Access Compliance Report

Public Rights-of-Way

Intersection ID: 10637	Main Street: COKER_AV	Cross Street: MATHIS_DR	Location: S
ADA ID: 3EEC2D1B09E8	Ramp Type: BlendTrans2	Initial Pass/Fail: Fail	Overall Compliance: No
		Severity Score: 1.25

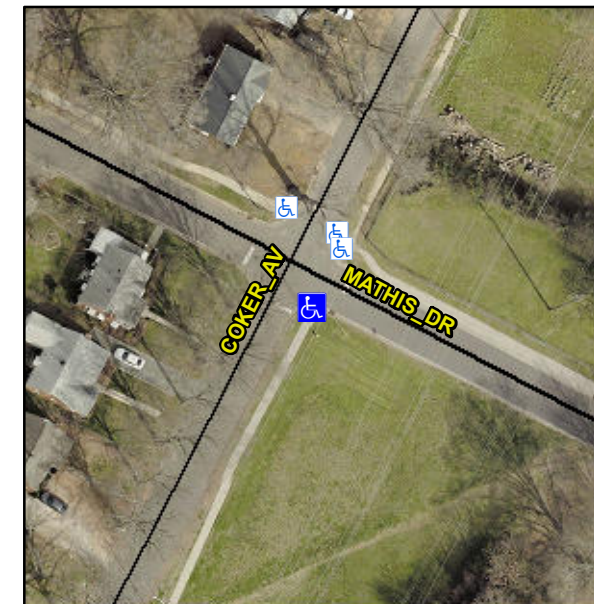
Not Found, R304.5.3

Compliance	Description	Data	Compliance	Description	Data
N/A	Ramp Length (in)	95.0	Yes	BlendTrans Slope (%)	4.6
Yes	Ramp Width (in)	60.0	No	BlendTrans XSlope (%)	3.9
N/A	Flare Type LT	N/A	N/A	Flare Type RT	N/A
N/A	Flare Slope LT (%)	N/A	N/A	Flare Slope RT (%)	N/A
N/A	Flare Traversable LT?	N/A	N/A	Flare Traversable RT?	N/A
N/A	Landing Length (in)	N/A	N/A	DWS Provided?	N/A
N/A	Landing Width (in)	N/A	N/A	DWS Contrast?	N/A
N/A	Landing Slope (%)	N/A	N/A	DWS Length (in)	N/A
N/A	Landing X Slope (%)	N/A	N/A	DWS Full Width?	N/A
N/A	Landing Curb? (Y/N)	N/A	N/A	DWS Offset (in)	N/A
N/A	Shared Landing?	N/A			
N/A	Gutter Ponding?	N/A	N/A	Gutter Slope (%)	N/A
N/A	Gutter Lip Ht (in)	N/A	N/A	Gutter X Slope (%)	N/A
N/A	Painted X Walk1?	No	N/A	Painted X Walk2?	N/A
	X Walk 1 Direction	To NE		X Walk 2 Direction	N/A
	X Walk 1 Width (in)	N/A		X Walk 2 Width (in)	N/A
	X Walk 1 Slope (%)	5.0		X Walk 2 Slope (%)	N/A
	X Walk 1 X Slope (%)	0.1		X Walk 2 X Slope (%)	N/A

N/A	Ramp inside XWalk1?	N/A	N/A	Ramp inside XWalk2?	N/A
	Road Slope (%)	0.1		Clear Space?	N/A
	Road X Slope (%)	5.0	N/A	Clear Space to XWalk (in)	N/A
N/A	Any Obstructions?	N/A	N/A	Storm Grate/Utility Hazard?	N/A
	Obstruction Type			Storm Grate/Utility Type	
		N/A			N/A
			Yes	Surface Condition? (G/P)	Good
			No	Curb Slope (%)	5.2

Remove & Replace Curb Ramp With Two New Directional Ramps or Equivalent.
